Attachment 5  
to U-602512

50.59 Thermo-Lag  
Safety Evaluations

1.4 Title: EVALUATION OF THERMO-LAG IN FIRE ZONE A-1a

USAR Appendix E and F Revision

FIGURE 4.2.4.3-1  
 FIRE PROTECTION DEVIATION  
 DIESEL GENERATOR BLDG.  
 MEZZANINE FLOOR PLAN EL. 762'-0"  
 FIRE AREA D-8

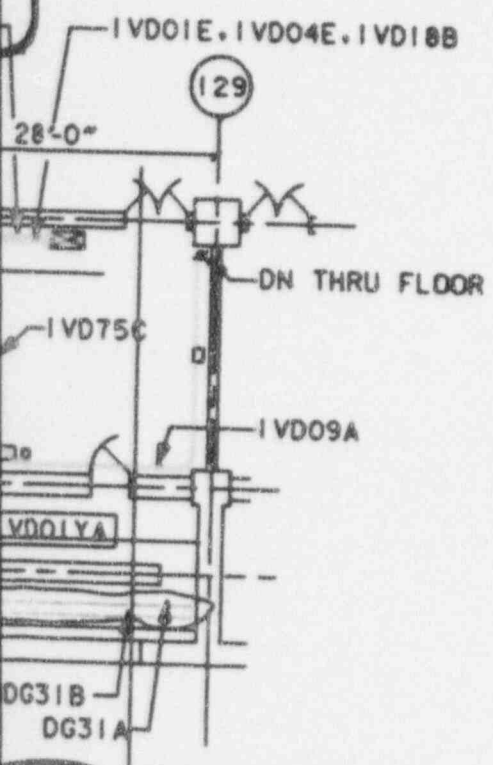
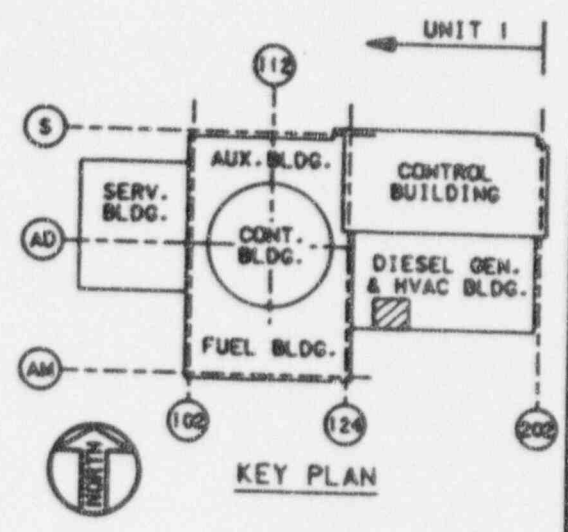
The Division 2 power feed cables, 1DG31A and 1DG31B (as shown on Figure 4.2.4.3-1), that run along the south wall of this fire area are separated from the Division 1 diesel-generator ventilation system by a missile shield and a partial concrete wall. The Division 2 cables will be protected with a 1-hour fire rated material and local thermal detection. The only combustibles in the area are electrical insulation in cabinets, HVAC duct insulation materials, and lubricants, resulting in a low fire loading. In the event of a fire in this fire area, safe shutdown can be achieved by the use of Division 2/Method 2 systems. Based on the provision of a 1-hour fire rated barrier and a partial fire detection system, low fire loading, and the ability to achieve safe shutdown, an automatic suppression system is not necessary in Fire Area D-8.

REVISE
